SYNRAD Product Change Notice

PCN #: 002-2016
Date: 09/15/2016
Product P/N: FSTi60SAG; FSTi60SFG; FSTi60SWG; FSTi60KFG;
FSTi60KWG

Description of Change: Upgraded ti60 RF Components

Fig 1. New Model Label Example

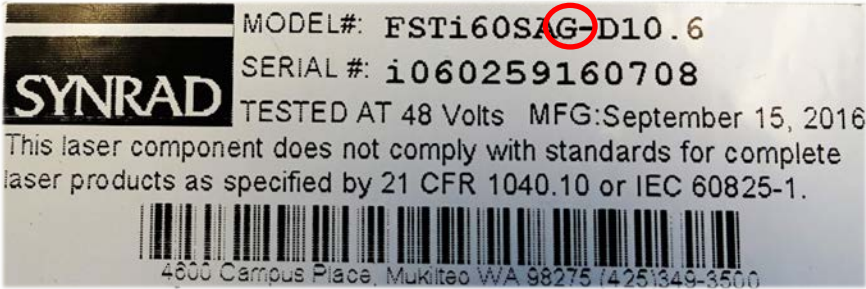
Units manufactured with the upgraded RF driver board will be designated by the revision letter "G". For instance, the ti60 fan model number will go from FSTi60SFE to FSTi60SFG.
